# Product Information Notice

**Models:** Tronic 3000-2R Electric Tankless Water Heaters

**Subject:** Sticking Flow Switch

Figure 1

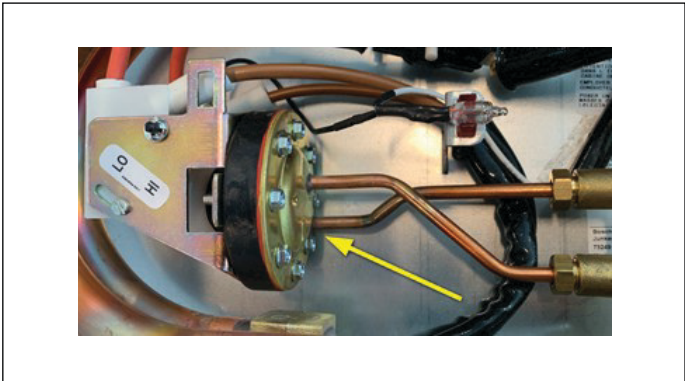
It has been identified that a number of flow switches that were used in the Bosch Tronic 3000-2R electric water heater products may have been assembled with insufficient lubrication.

This can result in the flow switch (see Fig.1) sticking and the water heater operating incorrectly.

If your water heater is one of the models listed in Table 1, is within the serial# range stated above, and is experiencing either of the two symptoms described above, we recommend that the flow switch be replaced immediately.

- Flow Switch Part#: **8-738-726-324** (compatible with all models listed in Table 1).

Figure 2

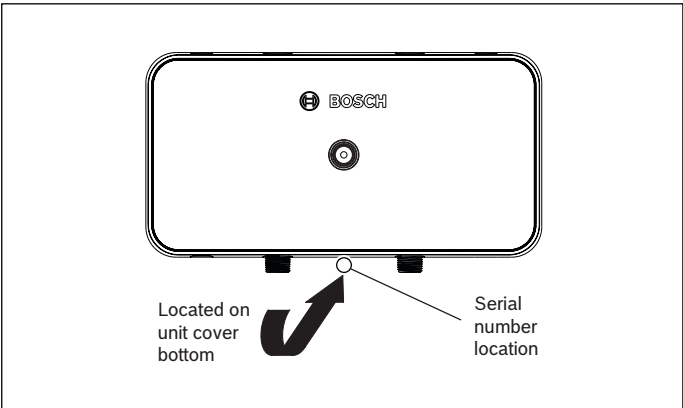
1. It is one of the specific models listed in Table 1 and is within the serial number range of FD 039 through FD 140 (the FD is located within the product serial number) .

**Serial Number Example:** 8370-176-002005-773650XXXX  
FD

See Fig.2 for location of the serial number.
